SIL 618

Service Information Letter

Units Affected: DLB, DMB, and D2000B, D3000B, D4000B Series Derricks
equipped with Radio Controls (see attached list)

Control Module Update

**Figure 1 — Typical Radio Control
With Load Indicator**

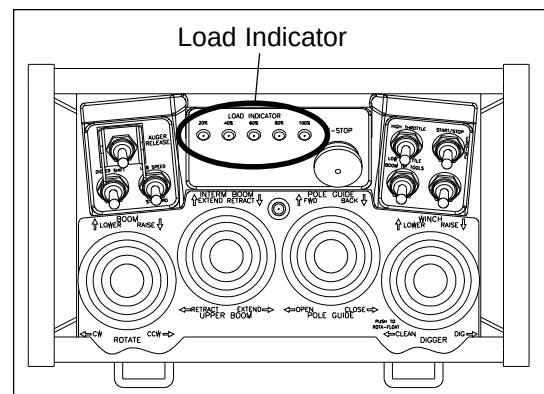
Digger derricks using radio controls with load indicators (refer to Figure 1) have been found to sometimes allow the digger and the winch to operate at the same time possibly causing damage to one or both functions. A change has been made to the radio control module which eliminates the possibility of the two functions working together.

Figure 2 — Control Module Location

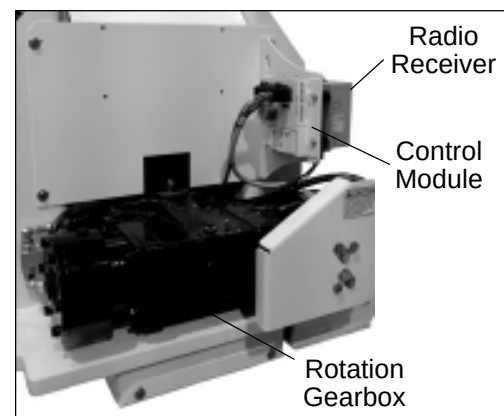
Altec requests owners to check the unit serial number and confirm that their unit is on the attached list. If the unit is on the list, order a replacement Control Module, part number 970476748, and replace the module no later than the next service interval. The control module is located at the rear of the turntable and can be easily replaced (refer to Figure 2).
